NRC DOCKETS 50-321, 50-366
OPERATING LICENSES DPR-57, NPF-5
EDWIN I. HATCH NUCLEAR PLANT UNITS 1, 2
NUREG-0737 ITEMS II.F.1(4) CONTAINMENT PRESSURE MONITOR,
II.F.1(5) CONTAINMENT WATER LEVEL MONITOR,
II.F.1(6) CONTAINMENT HYDROGEN MONITOR

ENCLOSURE 1
ADDITIONAL INFORMATION REGARDING NUREG 0737 ITEMS
II.F.1.4 CONTAINMENT PRESSURE MONITOR
II.F.1.5 CONTAINMENT WATER LEVEL MONITOR
II.F.1.6 CONTAINMENT HYDROGEN MONITOR

CONTAINMENT PRESSURE MONITOR LOOPS
HNP1

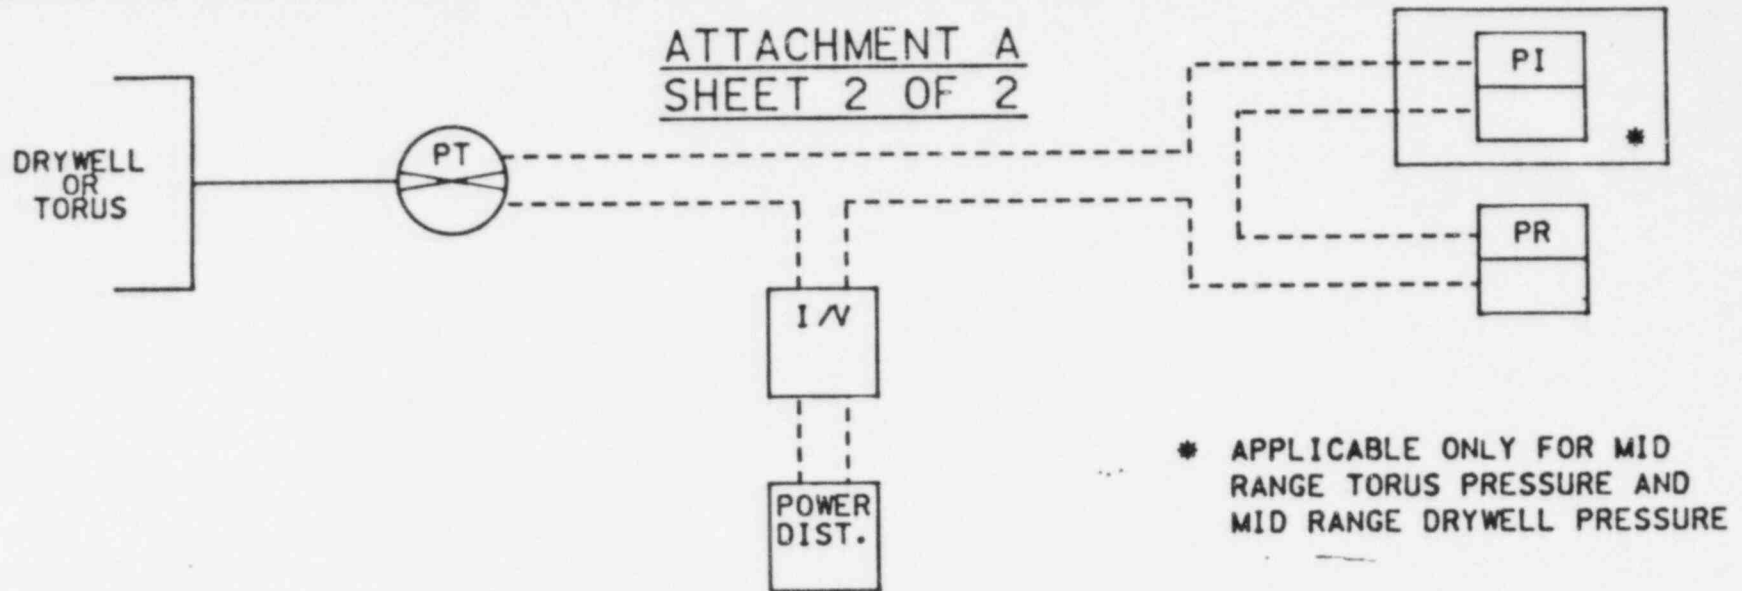
- (a) "Provide a block diagram of the configuration of modules that make up your PMS. Provide an explanation of any details in the block diagram that might be necessary for an understanding of your PMS accuracy and time response."
- (b) "For each module provide a list of all parameters* which describe the overall uncertainty in the transfer function of that module."

- (a) Attachment A provides block diagrams of the configuration of modules that make up the PMS for Plant Hatch Units 1 and 2.
- (b) The following is a list of all parameters used to compute the overall uncertainty in the transfer function of each module of the PMS instrument loops shown in Attachment A:

CONTAINMENT WATER LEVEL MONITOR LOOPS
HNP1

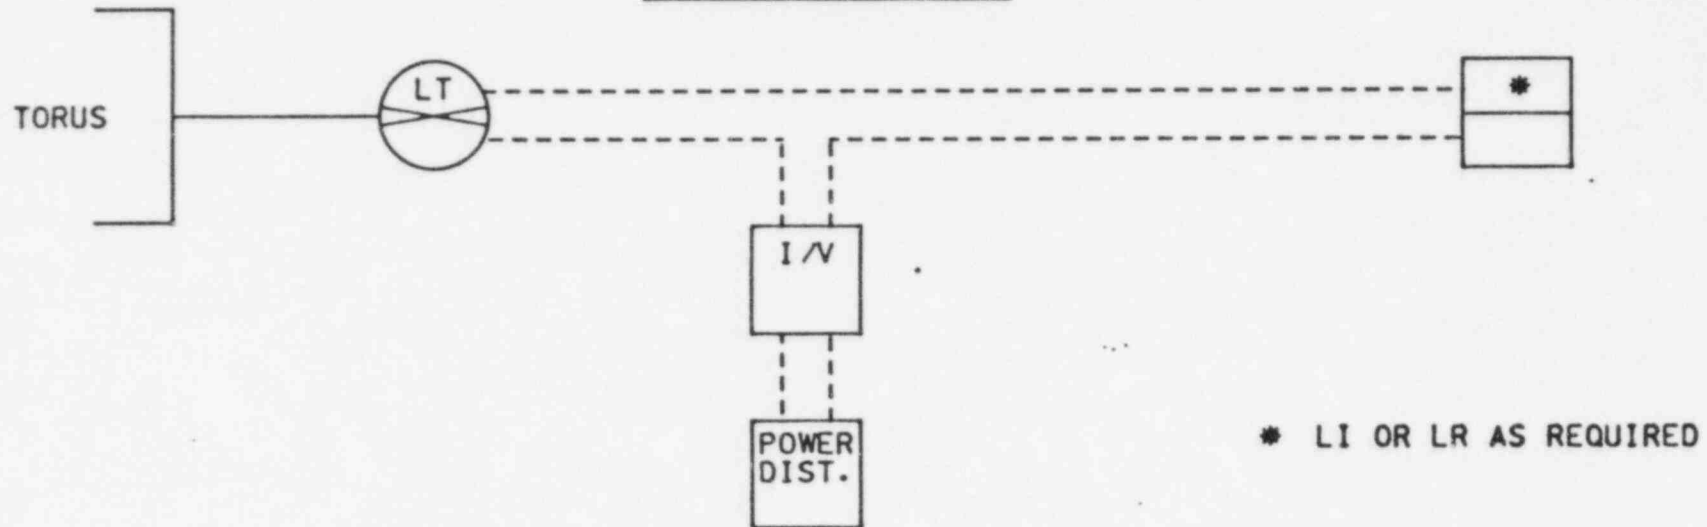
- (a) "Provide a block diagram of the configuration of modules that make up your WLMS. Provide an explanation of any details in the block diagram that might be necessary for an understanding of your WLMS accuracy."
- (b) "For each module provide a list of all parameters* which describe the overall uncertainty in the transfer function of that module."
- (c) "Combine** parameters in 3b to get an overall system uncertainty. If you have both strip chart recorder and indicator output, give the overall system uncertainty for both systems. If you have systems spanning different ranges, give the overall system uncertainty for each system."

- (a) Attachment B provides block diagrams of the configuration of modules which make up the WLMS at Plant Hatch Units 1 and 2.
- (b) The following is a list of all parameters used to compute the overall uncertainty in the transfer function of each module in the WLMS.
 - 1. Rated accuracy
 - 2. Repeatability
 - 3. Power supply change effects
 - 4. Hysteresis effect
 - 5. Deadband effect
 - 6. Calibration accuracy
 - 7. Drift
 - 8. Temperature change effects
 - 9. Radiation effects
 - 10. Seismic effects
